Application Type:

Conditions of Approval:

HILCORP ENERGY COMPANY
San Juan 29-5 Unit 55F
PICTURED CLIFFS RECOMPLETION SUNDRY

CASING REPAIR, WORKOVER, AND RECOMPLETION CONDITION OF APPROVAL

San Juan 29-5 Unit 55F - CURRENT WELLBORE SCHEMATIC

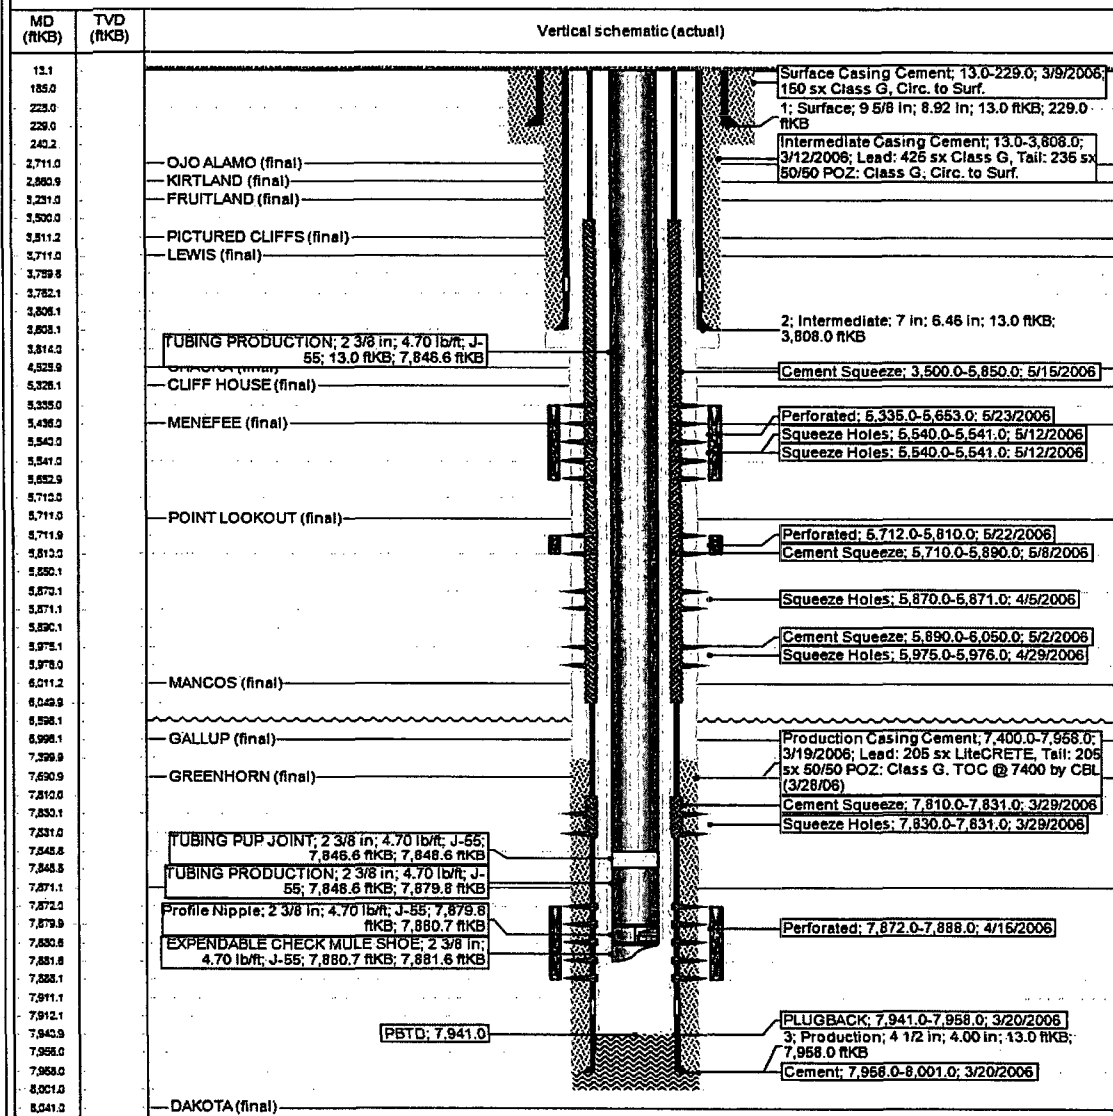
- Notify NMOCD 24hrs prior to beginning operations.
- Based on the 2006 CBL the well appears to need remediation prior to recomplete with a TOC at 3470'. The current cement coverage from the top perf to the TOC at 3534' only provides 64' of cement coverage with a 60%-65% bond. Submit the proposed remediation plan to the agencies for review and approval prior to starting remediation.
- Perform a witnessed mechanical integrity test (MIT) after remediation. Provide at least 24hrs notice to the agencies prior to the MIT.
- Submit the subsequent cement bond log (CBL) to the agencies for review and approval prior to perforating for the recomplete.
- Hold C-104 for Down Hole Commingle (DHC) approval.
